Access Compliance Report

Public Rights-of-Way

(Pedestrian Signals)

Intersection ID: N/A	Main Street:	Cross Street: N/A	Location: N/A
ADA ID: D2C451977854	Signal Type: One Push Button-Non APS	Overall Compliance: No	Severity Score: BTN 1: N/A BTN 2: N/A No BTN: N/A
Codes/Mitigation Info/Possible Solution		Field Measurements/Component Compliance

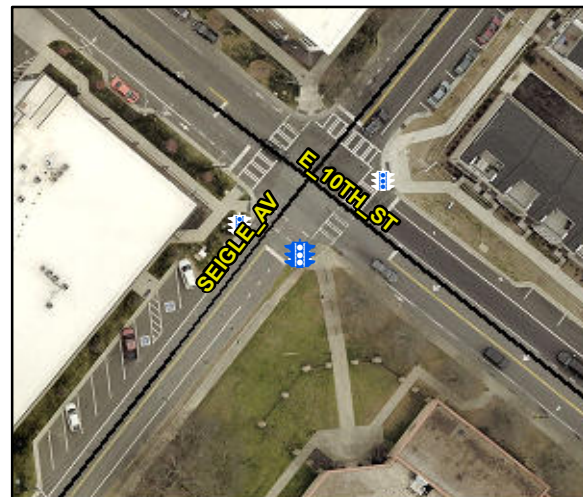
Surveyor Notes: BUTTON NOT OPERATIONAL

Possible Solutions: Replace Signal Push Button With APS Button. Provide Clear Space.
